124 DENNY WAY MIXED-USE

**Design Review
Recommendation Meeting**
March 25, 2015
DPD #3015549

EARLY DESIGN GUIDANCE

EDG RESPONSE:

EDG MASSING

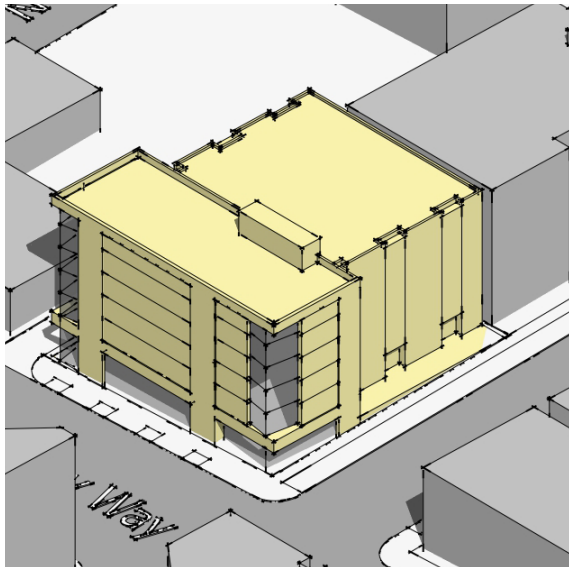
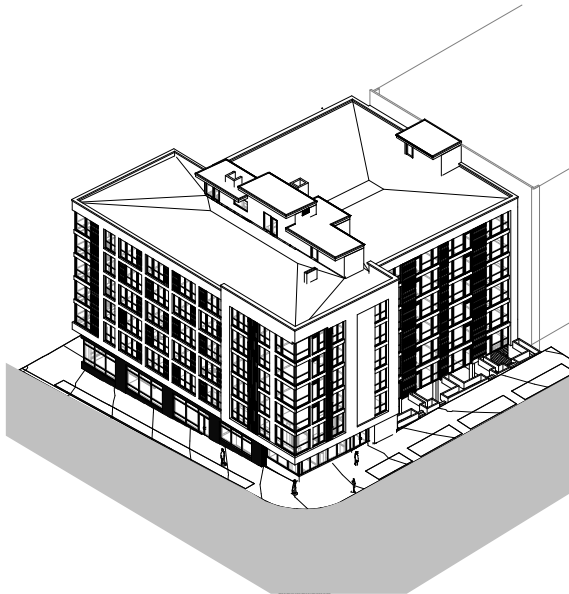
BOARD SPECIFIC GUIDANCE: Keep the modulation as shown. The north portion of the structure seems more modulated for residential use.

RESPONSE: The modulation has been retained. The building is broken down into two prominent masses. The consistent framework of the southern bar allows it to read as a whole, with smaller facade articulation providing interest and texture. The northern bar has a more residential, tripartite design with strong vertical elements broken down with the addition of decks, glazed guard rails, and a deeper exterior wall, creating shade and shadow and a more residential articulation of units.

CONTEXT AND SITE: CORNER SITES

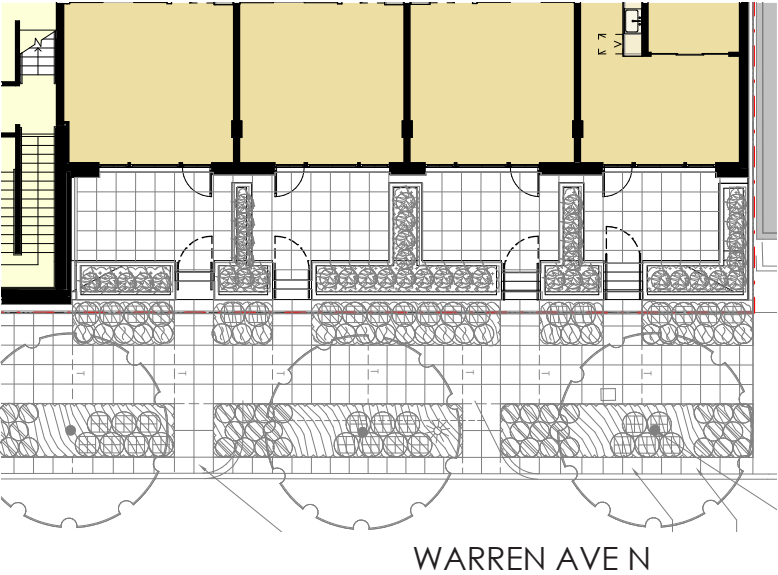
BOARD SPECIFIC GUIDANCE: The Board noted that given the shifting of the street grid at Denny the alley corner will be prominent, especially from Bay St. The corner treatment is very important and does not need to be treated the same as the corner at Warren Ave N.

RESPONSE: The high visibility of the corners of Denny Way and Warren Ave N is reflected in the prominent corner treatment and material placement, with extensive glazing on both corners of the project. The SW corner has wrap-around decks and window patterning that matches the south elevation, while the SE corner's prominence is emphasized by both wrap-around decks, facade articulation, and bold materials and textures. The residential entrance/lobby is located prominently on the SE building corner, signified by an overhead canopy, accent material above the entry, and floor to ceiling glazing.

WARREN AVE N - PATIOS

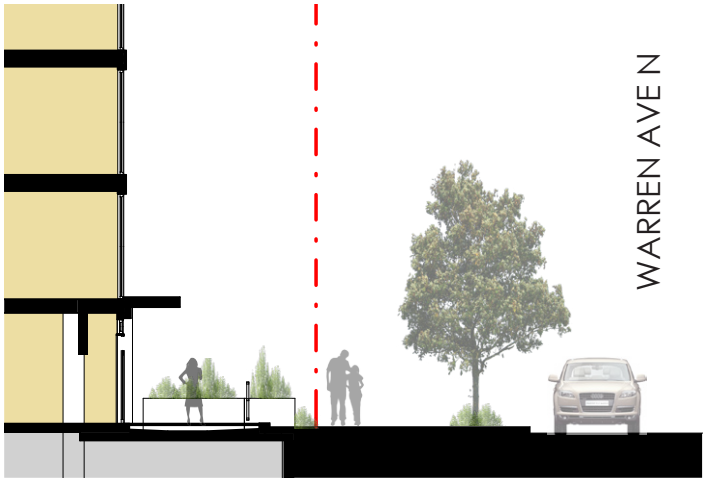
BOARD SPECIFIC GUIDANCE: Provide patios for the residential units off of Warren Ave. N. that will be primarily private. Maintain the 12' setback and use landscaping along Warren Ave N to provide a sense of protection and privacy for the residential entries.

RESPONSE: The east patio setback has been increased to 14' back from the sidewalk edge. The patios adjacent to Warren are primarily private. Steps, gates, and raised planters and landscaping provide a grade change and buffer between the sidewalk traffic and the residential units.

ALLEY VIEW FROM DENNY WAY

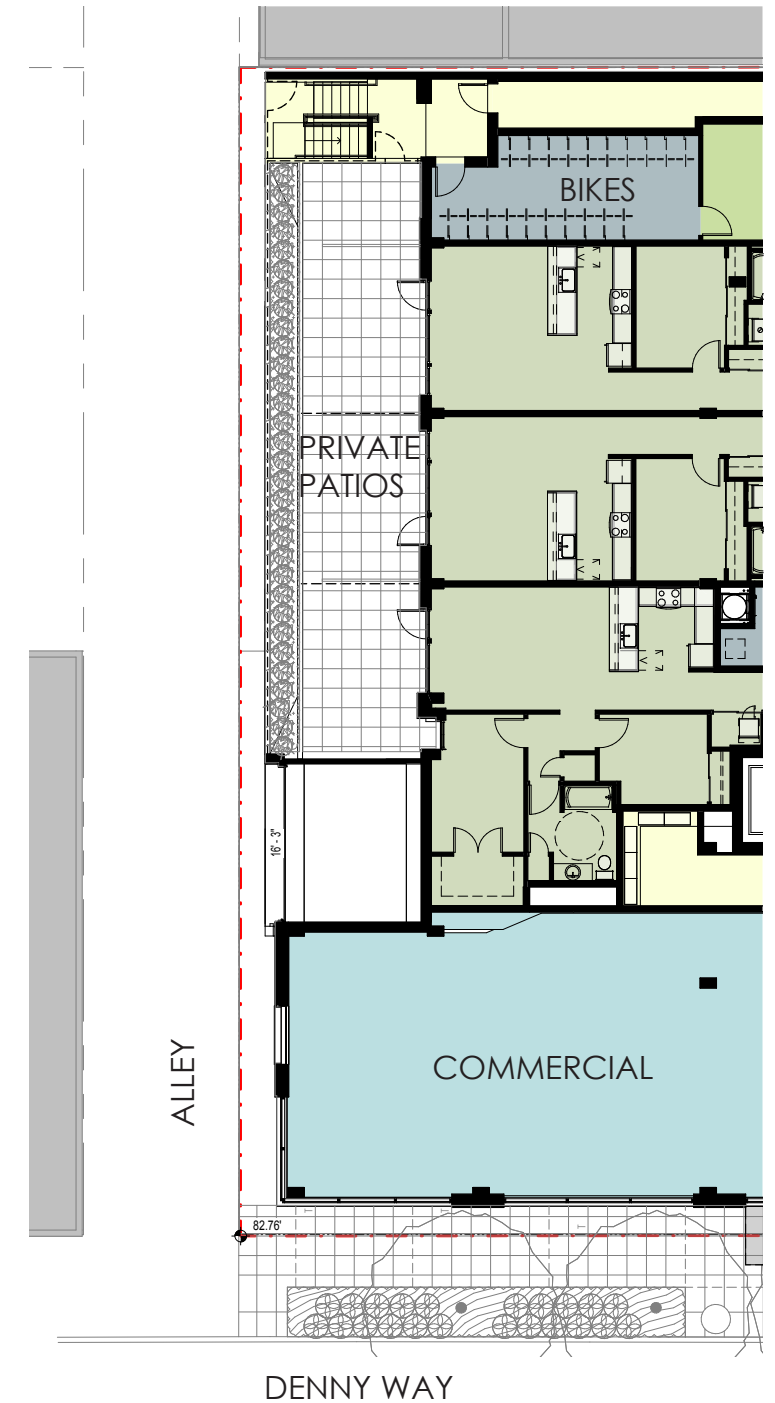
BOARD SPECIFIC GUIDANCE: Provide a staging area on the north side of the driveway for solid waste on collection day that will work for SPU and building staff. Design the driveway for safety of pedestrians and vehicles. Consider narrowing the width of the driveway. The Board encouraged the design of the patio units above the alley, provide security.

RESPONSE: The units facing the alley will help activate the alley. The raised patios are above the alley by an average of 4'-6". A 2' high planter on the west side of the patio softens the space, while a metal and wood screen provides both privacy and security. A locked access gate at the alley provides residents access to the building, and also allows a direct link to a secure bicycle storage room.

RESPONSE: Staging area is provided to the north of the driveway, adjacent to the garage entrance. Solid waste staging is located away from the sidewalk pedestrian zone. Operationally, there will be two pick-up days, with the container pushed out to the alley by building maintenance for pick-up by SPU. Garage access is provided off of the existing alley, minimizing conflicts between vehicles and pedestrians. The driveway width is designed for both vehicles and pedestrians, safety devices such as mirrors, and audible alerts, may be installed. The driveway is narrowed and proposed to be 16' (departure request). Multiple approaches towards safety at the alley will be considered, including security screening, lighting, and well-marked entries.

DESIGN DEPARTURE #1

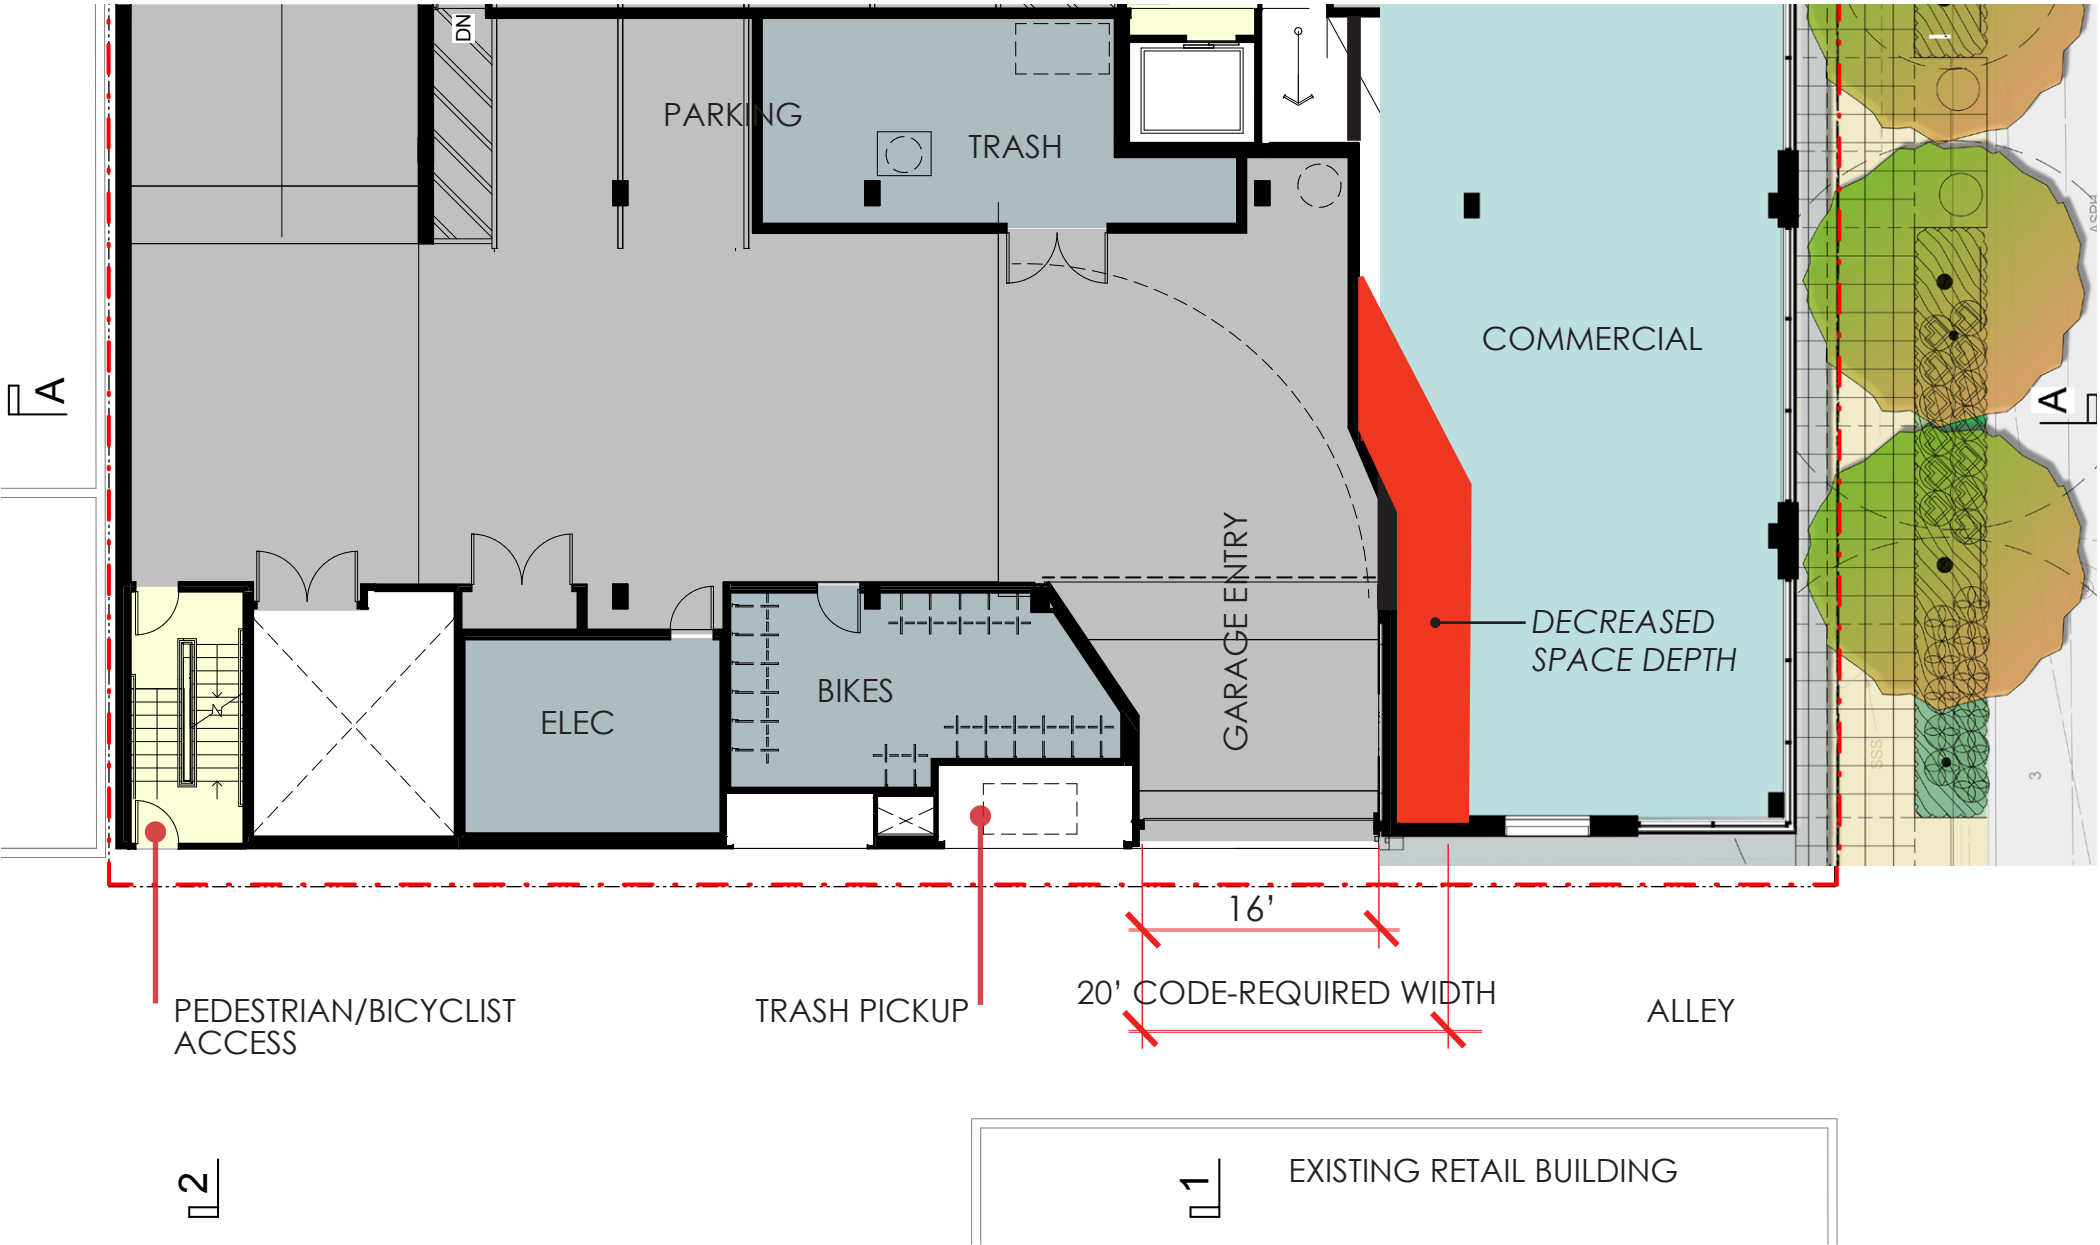
EDG COMMENTS:
The Board indicated they are inclined to grant this departure and noted a width of 10' may be supported to increase the depth of the retail space. By narrowing the driveway width the retail space off of Denny Way can have greater depth and will not need a departure. (PL2.I.ii)

PROPOSED DEPARTURE: Allow the parking entry ramp to decrease from the required 20' width to 16' width.

RATIONALE: Granting this departure keeps the massing concept of the north and south bars architecturally consistent. Widening the driveway would disrupt the composition of the west elevation, and create concept inconsistencies (DC2-B-1). Also, the retail space depth of an average of 30' is provided for with the reduced driveway width.
